Township of Lawrence
ENGINEERING DEPARTMENT

SUBJECT: Major Site Plan – Preliminary & Final Approval Application No. SP-2/22
40 Enterprise, LLC, 40 Enterprise Avenue
Tax Map Page 6, block 601, Lots 1 – 8

DATE: May 24, 2022

Re: **40 Enterprise LLC**
Preliminary and Final Major Site Plan
Block 601 Lots 1 - 8
40 Enterprise Avenue
Enterprise Avenue Redevelopment Area
Application No. SP-2/22

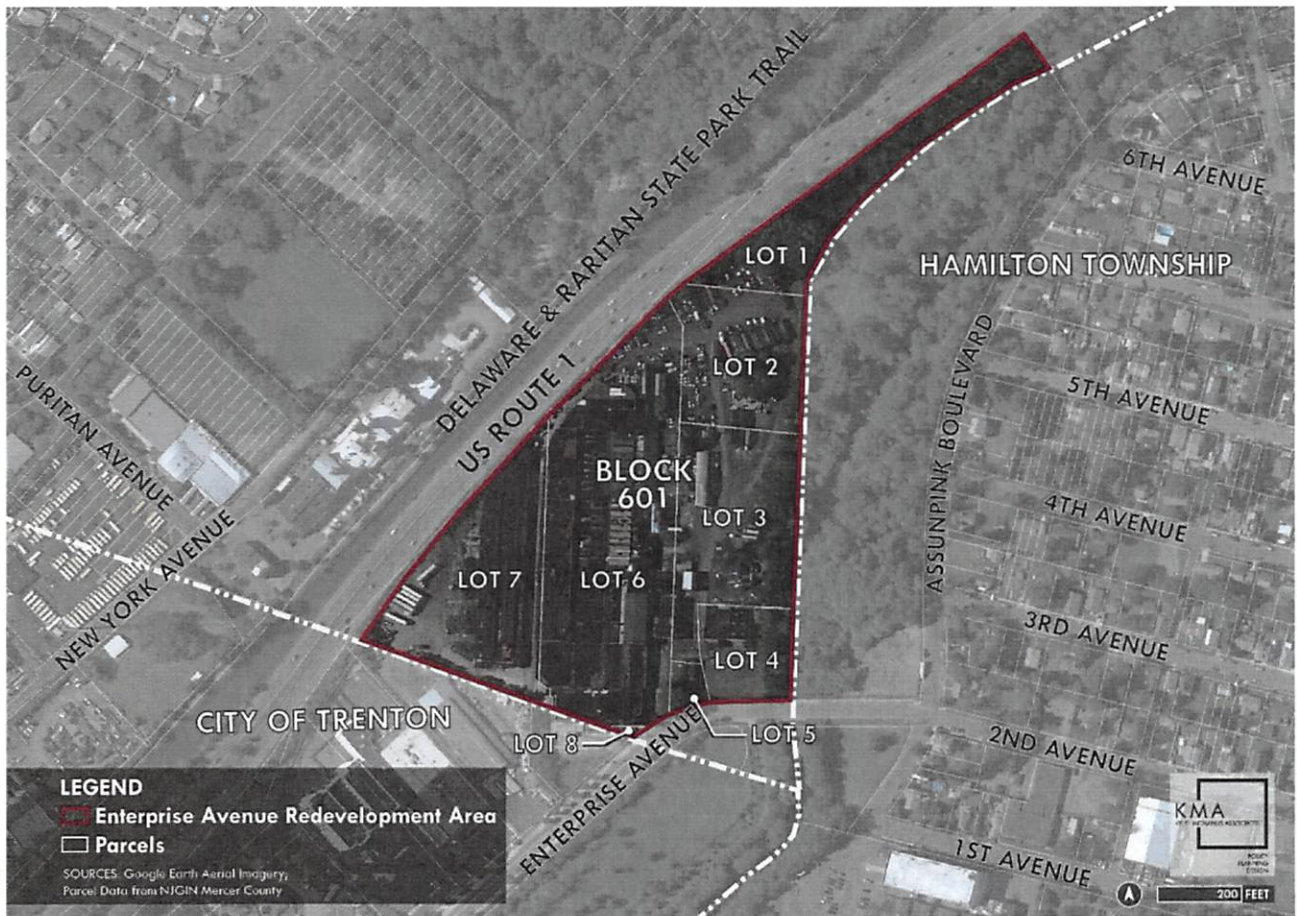
- 4.5 There appears to be outdoor trash and debris throughout site. The Applicant should confirm the removal of all trash and debris.

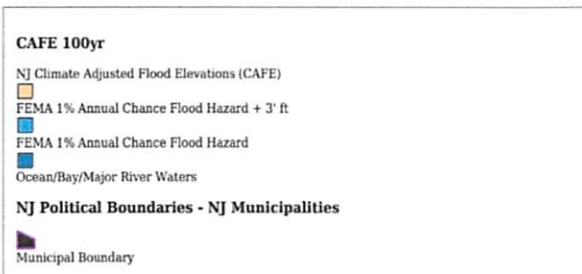
1. Migration of contamination from site disturbance.
2. Impact of runoff during storm events, especially severe weather events and flooding.
3. Volatilization to indoor air pathway (VIAP) as it appears the building may be located at a TCE plume.
